| 1.2 PCI No.          |   | ADG/20/12528   |
| 1.3 Title of PCI     |   | Orientation of PowerFLAT 8X8 HV Package in carrier tape & Datasheet update |

### **Orientation of PowerFLAT™ 8X8 HV Package in carrier tape**

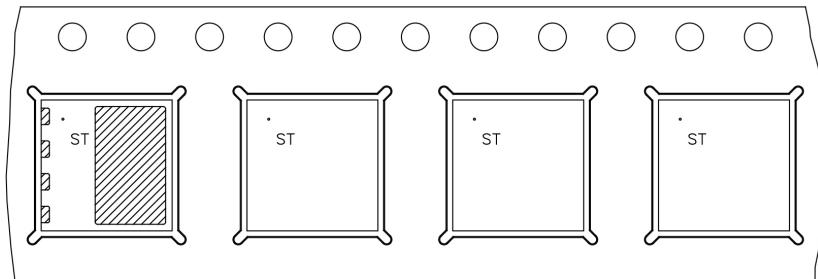
*Purpose of the current notification, is to inform you that despite what is stated in the **PCI ADG/20/12232**, published on June 26, 2020, we are going to restore the PowerFLAT™ 8x8 HV package orientation in carrier tape to TOP LEFT. The change will also be reported in the relative datasheets.*

*We have gathered negative feedback from our customers and found that very few vendors follow the JEDEC / EIA specification, then the top right orientation creates a continuous equipment setup.*

#### **NEW PowerFLAT™ 8X8 HV top left Package orientation in carrier tape**

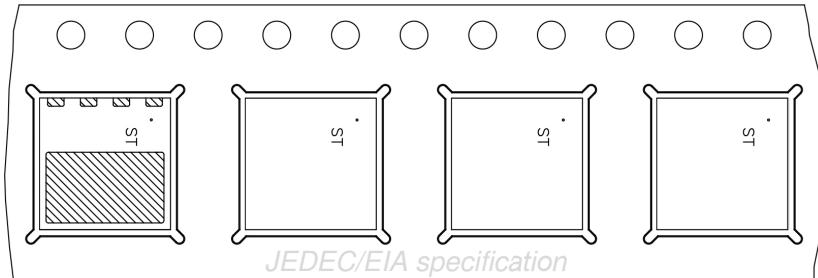
#### **Current PowerFLAT™ 8X8 HV top right Package orientation in carrier tape**
